Re: Detroit Coke Site Investigation Technical Memorandum, March 24, 1999

Re: Detroit Coke's November 4, 1997 Response to Notice of
Deficiency Regarding Detroit Coke Corporation's April 1996
RCRA Facility Investigation (RFI) Workplan

Subject: Response to Notice of Deficiency Regarding Detroit Coke Corporation's
April, 1996 RCRA Facility Investigation (RFI) Workplan

**ATTACHMENT I
RESPONSES TO U.S. EPA COMMENTS
RCRA FACILITY INVESTIGATION WORK PLAN
DETROIT COKE CORPORATION
DETROIT, MICHIGAN
MID 099 114 704**

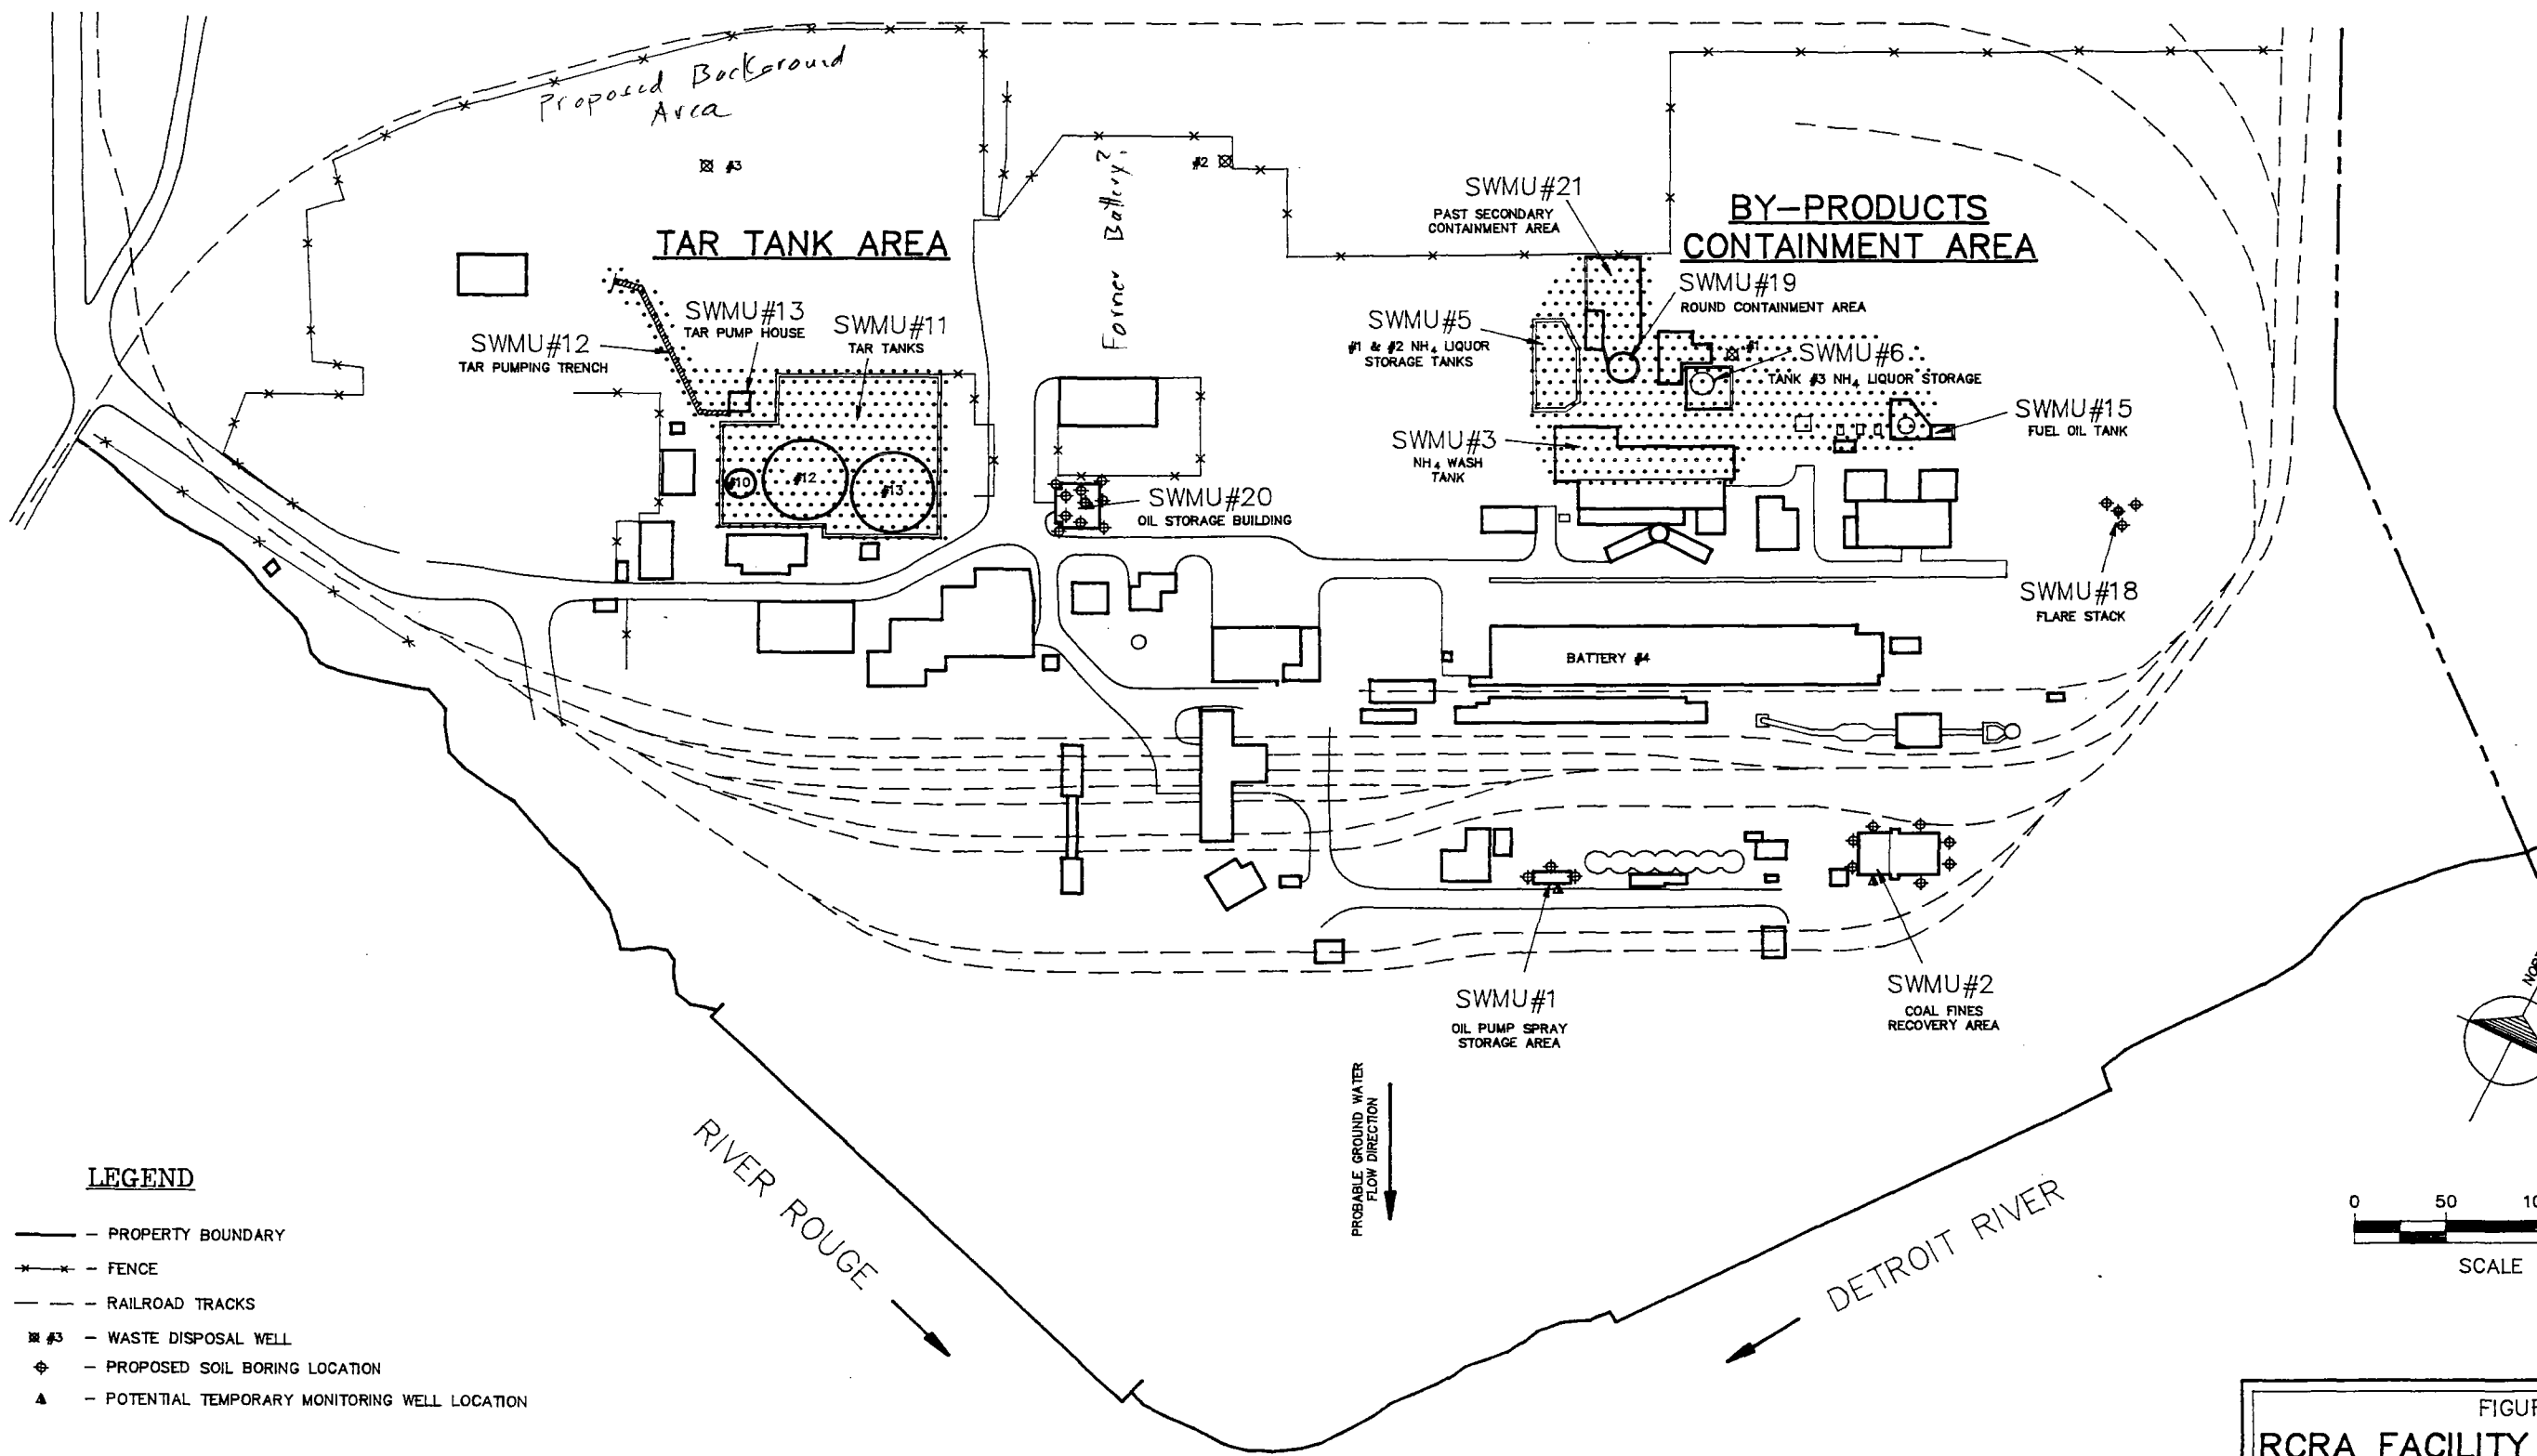
Description: This unit consisted of a 40 x 60 foot curbed concrete pad. Blind sumps were located in each corner of the pad to collect spills. The unit was used to store virgin oils prior to their use in the coking process. Detroit Coke demolished and removed the concrete pad, and capped the area with approximately 12 inches of clay to bring it back to grade.

Sampling and Analysis: Soil samples will be collected from depths of ~~2 to 3~~ feet to evaluate potential releases to shallow soils due to overflow or leakage of the shallow containment structure. Proposed soil sampling locations are shown on the attached site map. Actual sample locations may be modified in the field, based on any visual

observations indicating potential impact. Based on the comprehensive sampling and analysis plan for this SWMU, it is estimated that soil samples will be collected from a maximum of 10 soil borings. A maximum of 5 soil samples will be analyzed for release indicator parameters (purgeable aromatics and PNA's).
